## *1 Hastings Way*

Drawing No: 099 / AP3\_04

Title: Proposed Elevations

Revision: B

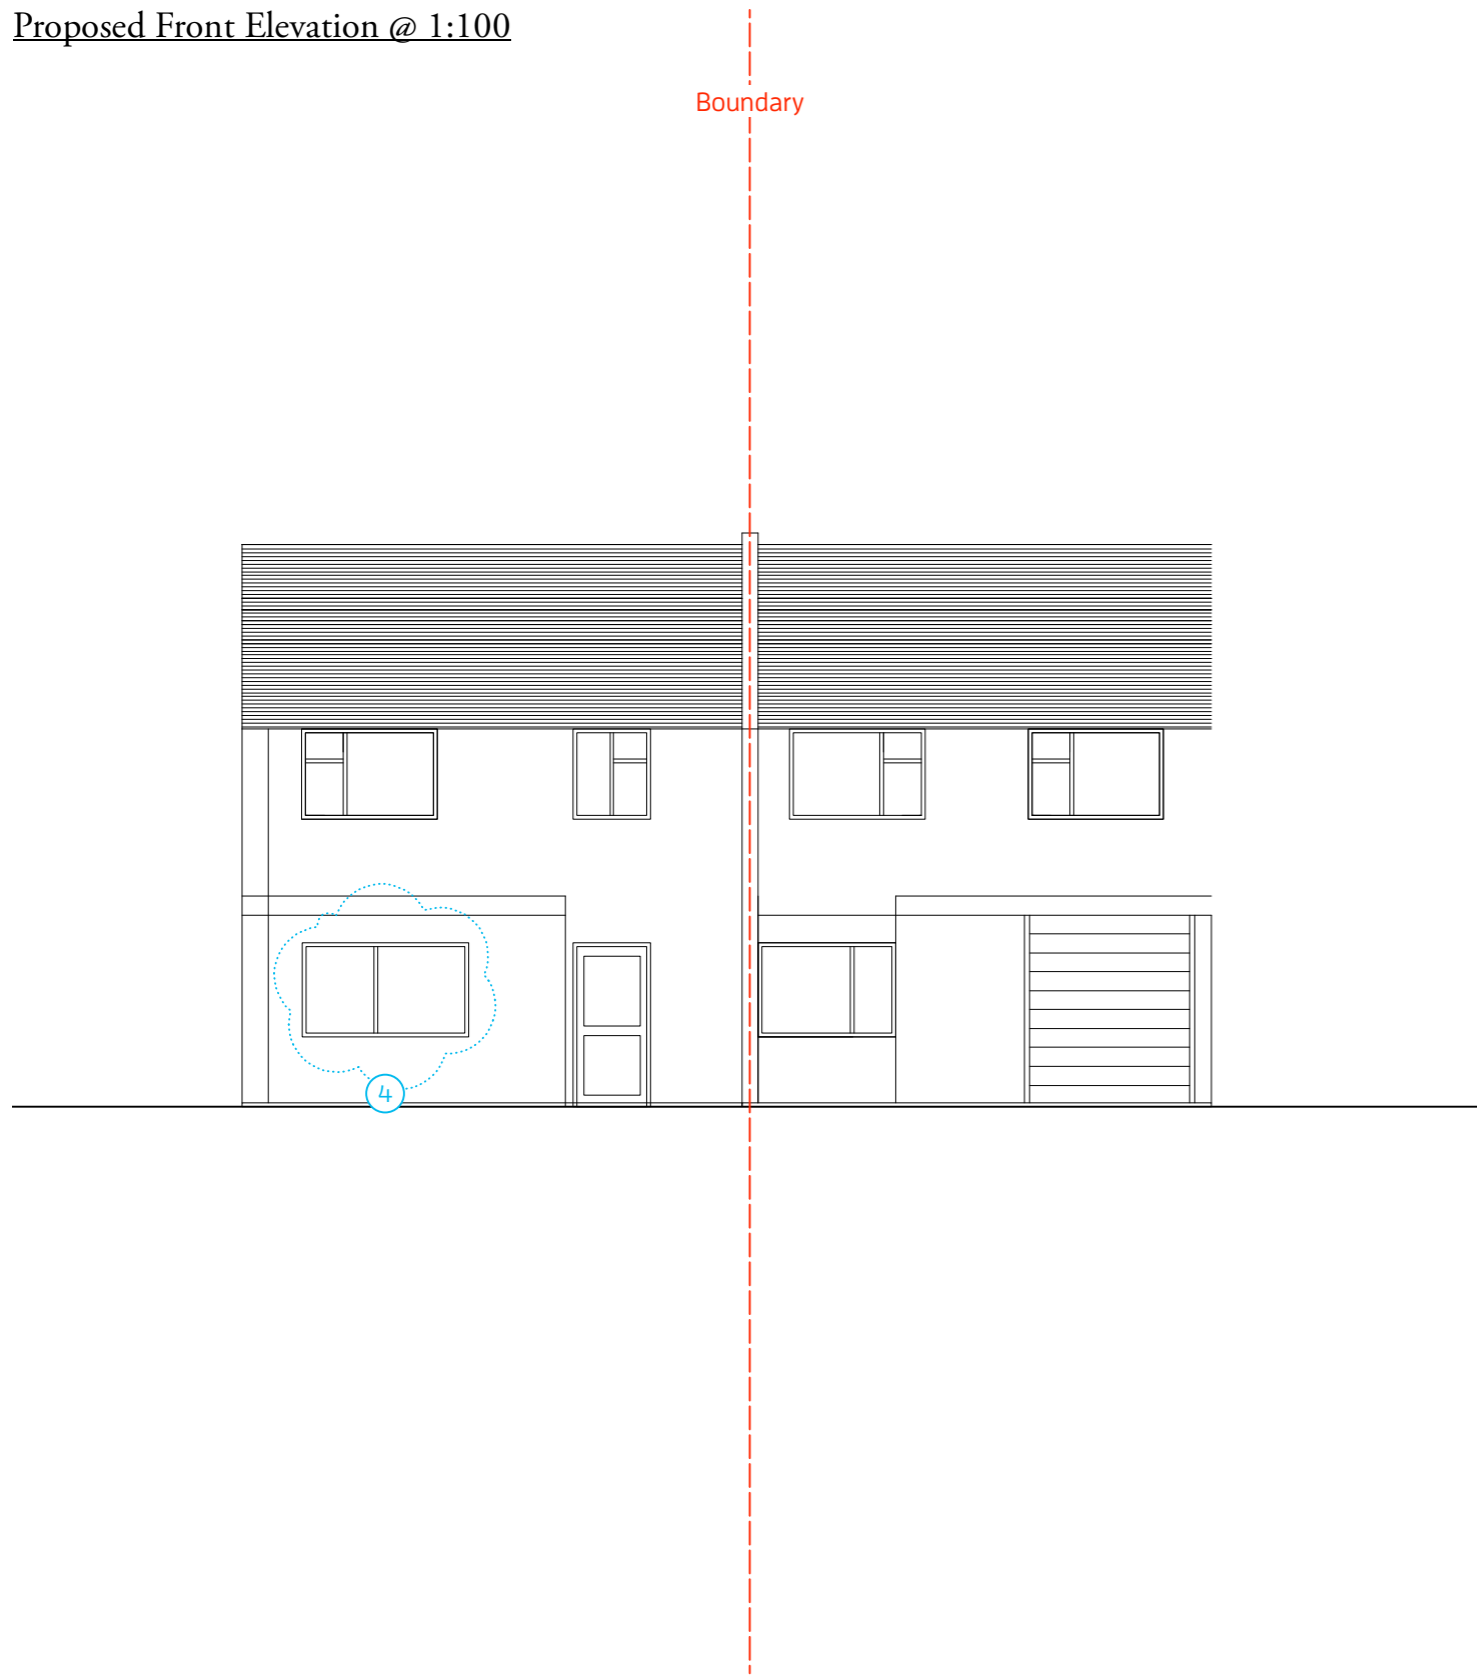
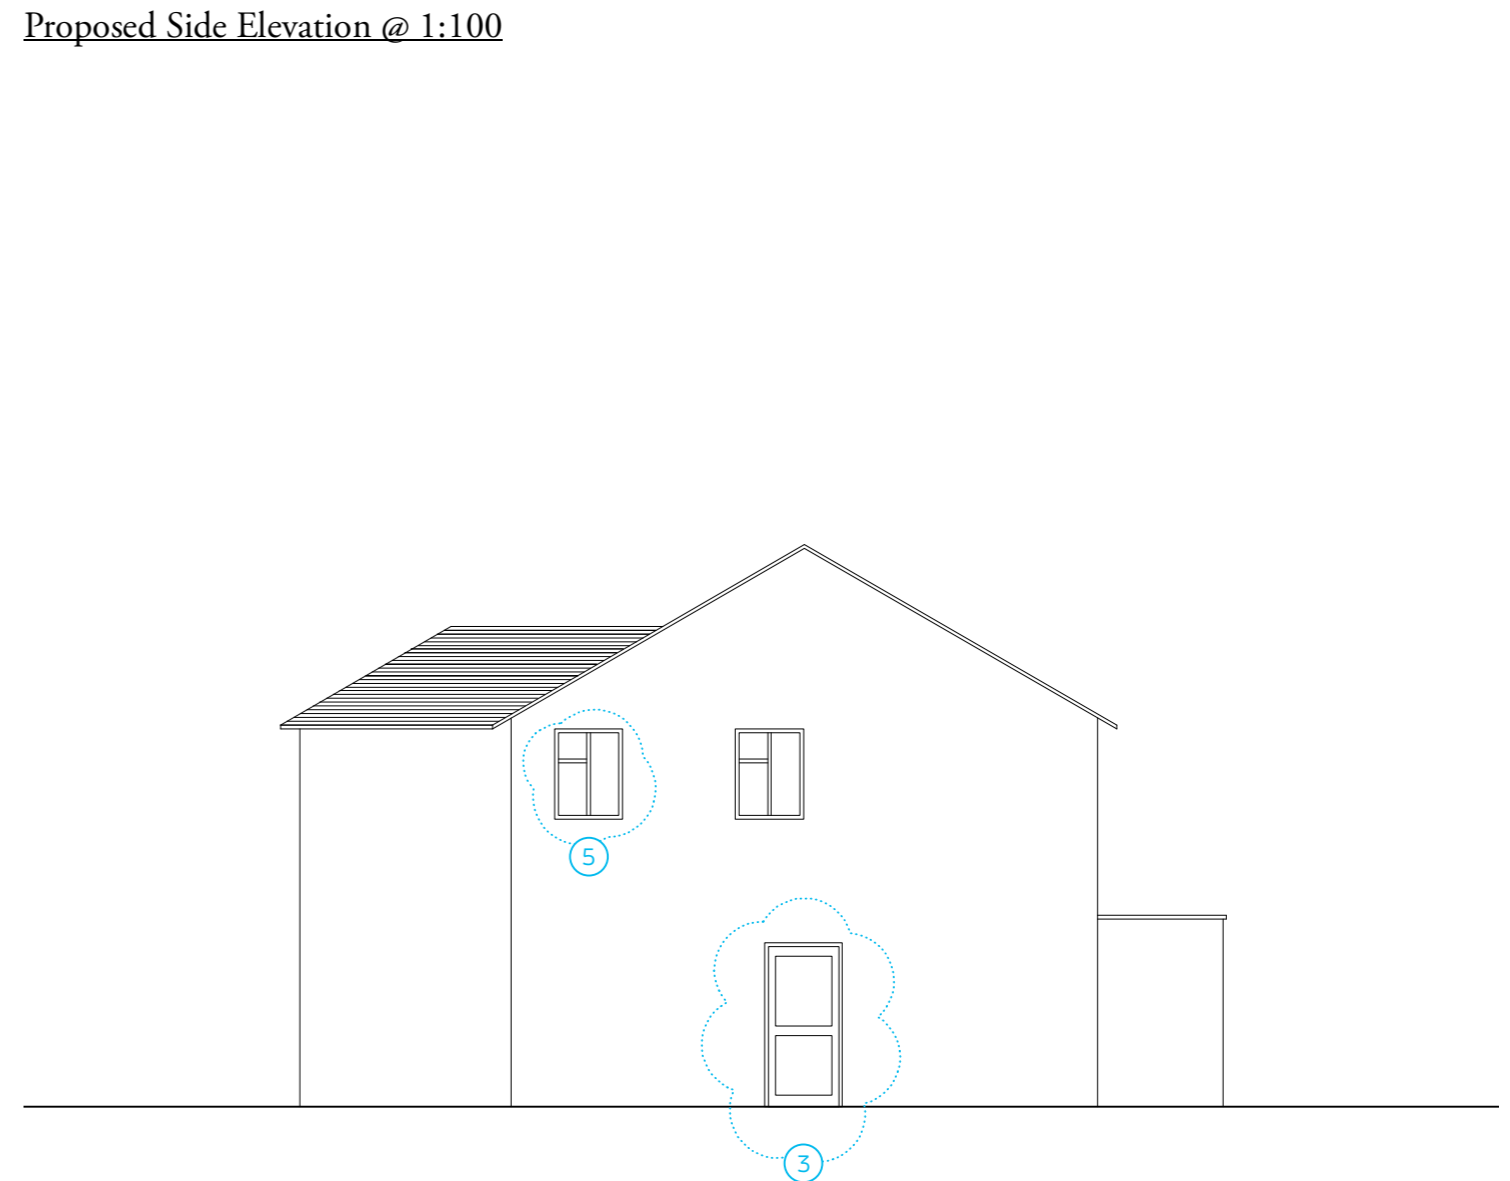
Summary Of Changes Made Since This Drawing Was Last Issued:

- 1) Structural Opening Now 1845 w / 2160 h. Was 1470 w / 1240 h;
- 2) Structural Opening Now 2575 w / 2160 h. Was 2200 w / 2160 h;
- 3) New Glazed Door With Frosted Finish To Glass;
- 4) Structural Opening Now 2200 w / 1240 h. Was 2030 w / 1240 h;
- 5) New Window With Frosted Finish To Glass;
- 6) Landscape Changes To Provide Side Access.
